Tompkins Cottage Orcas Island, WA

APPROVED TO CONSTRUCT
PER STATE BUILDING CODES
AS REQUIRED BY RCW 19.27.031
SUBJECT TO FIELD INSPECTION
AND CORRECTION

PERMIT SET

SHEET DESCRIPTION:
ROOF FRAMING PLAN

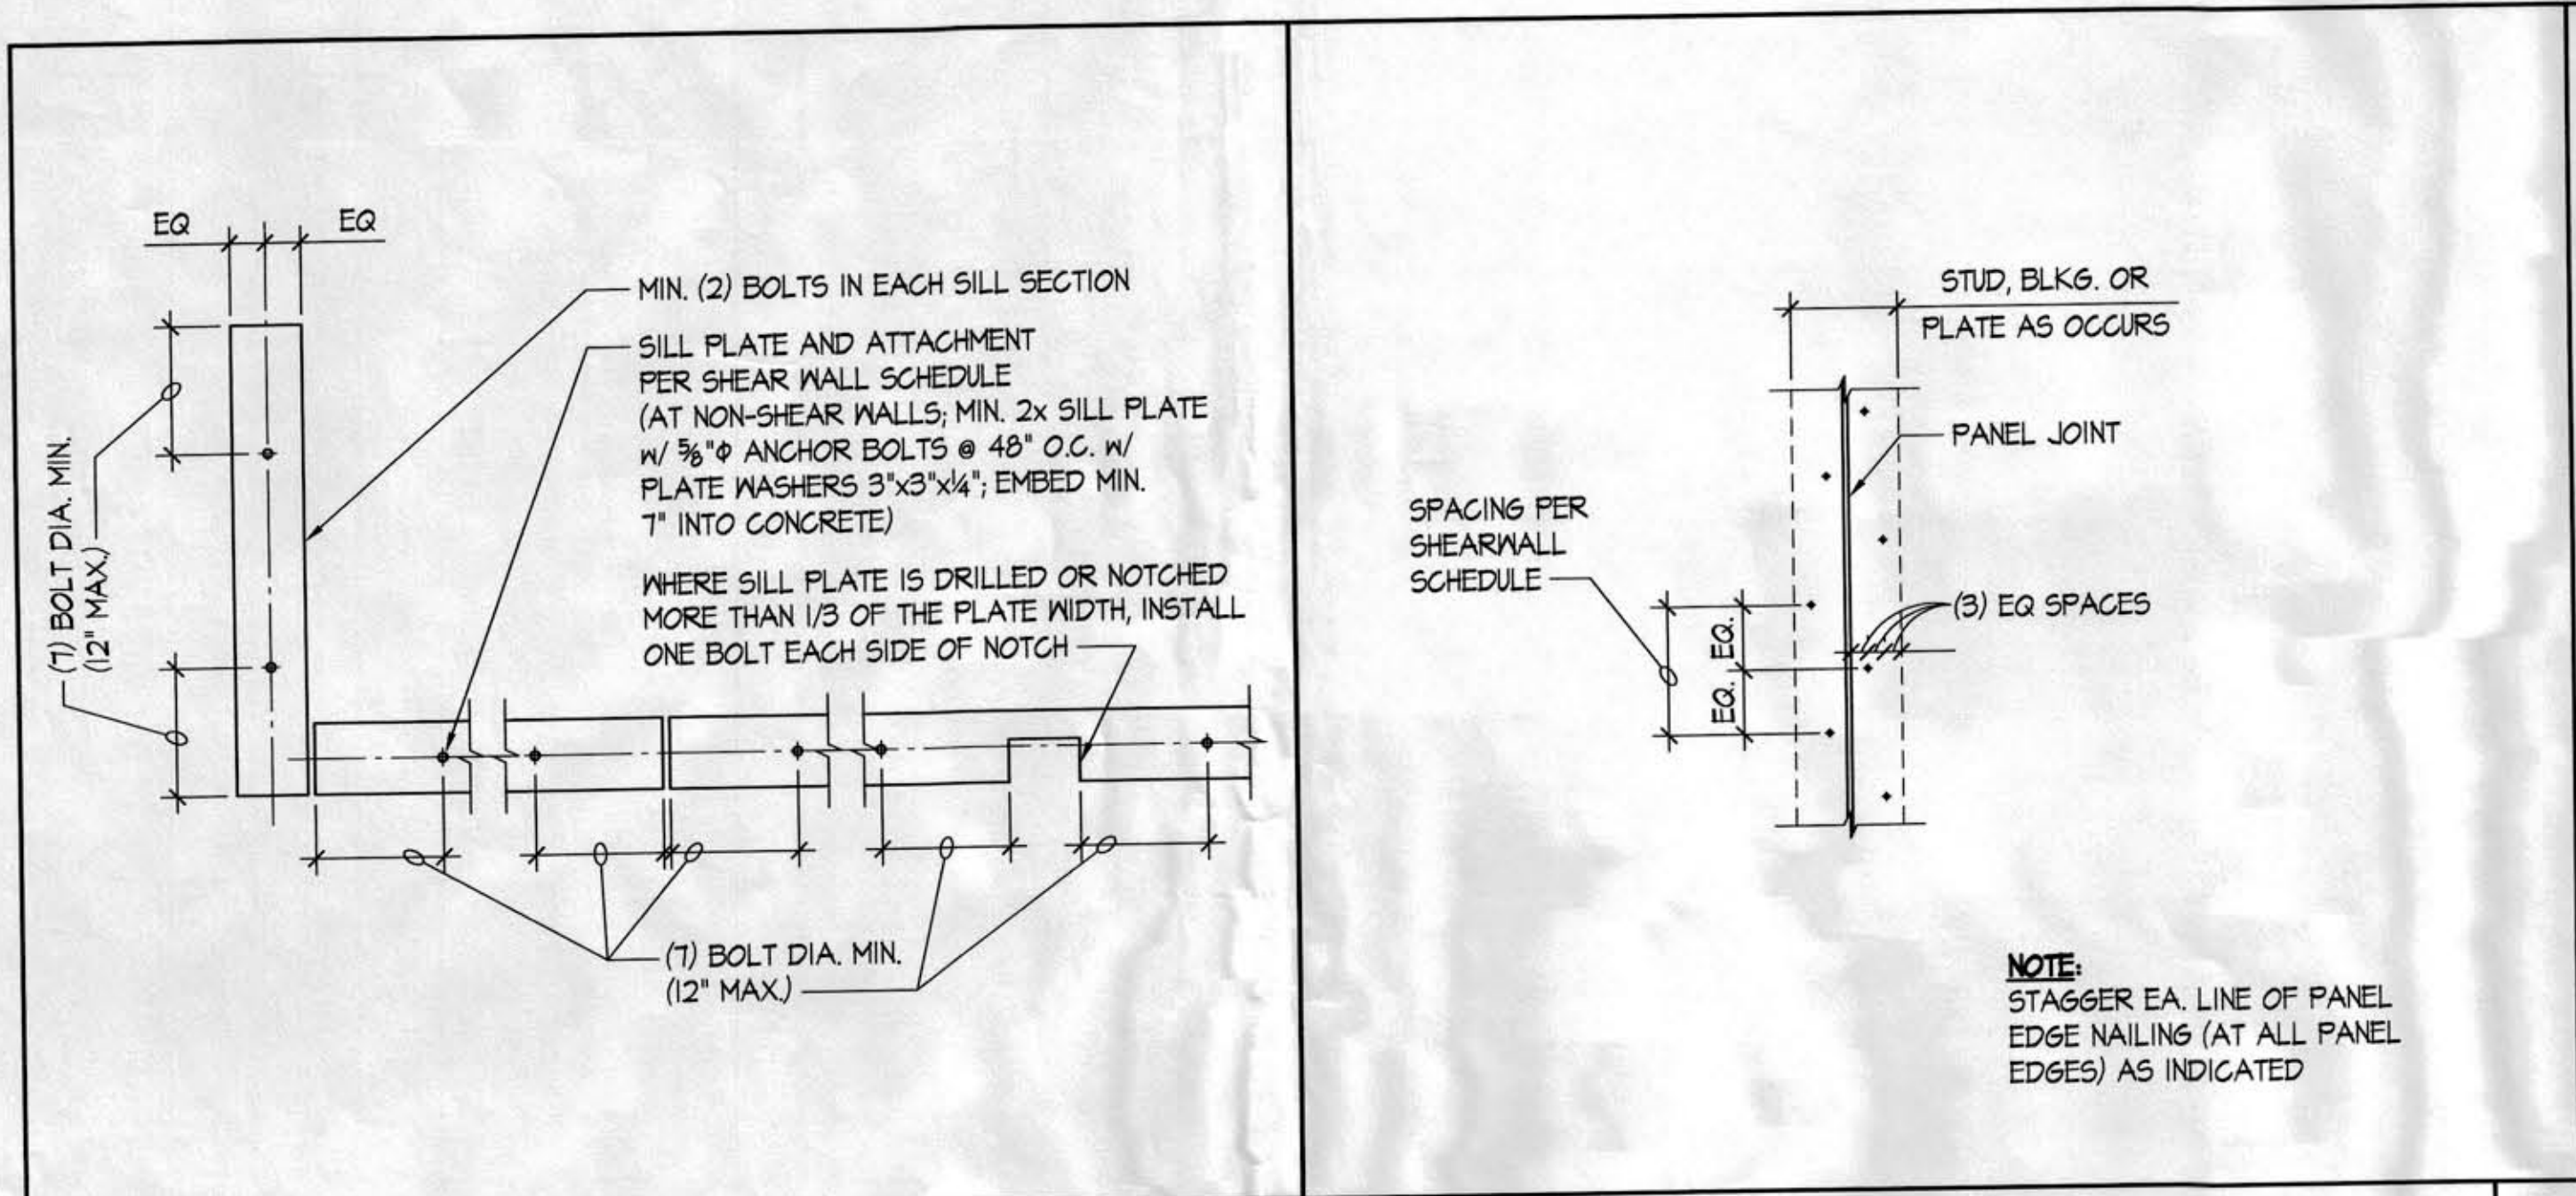
PROVIDE TRUSS SPECS @ FRAMING
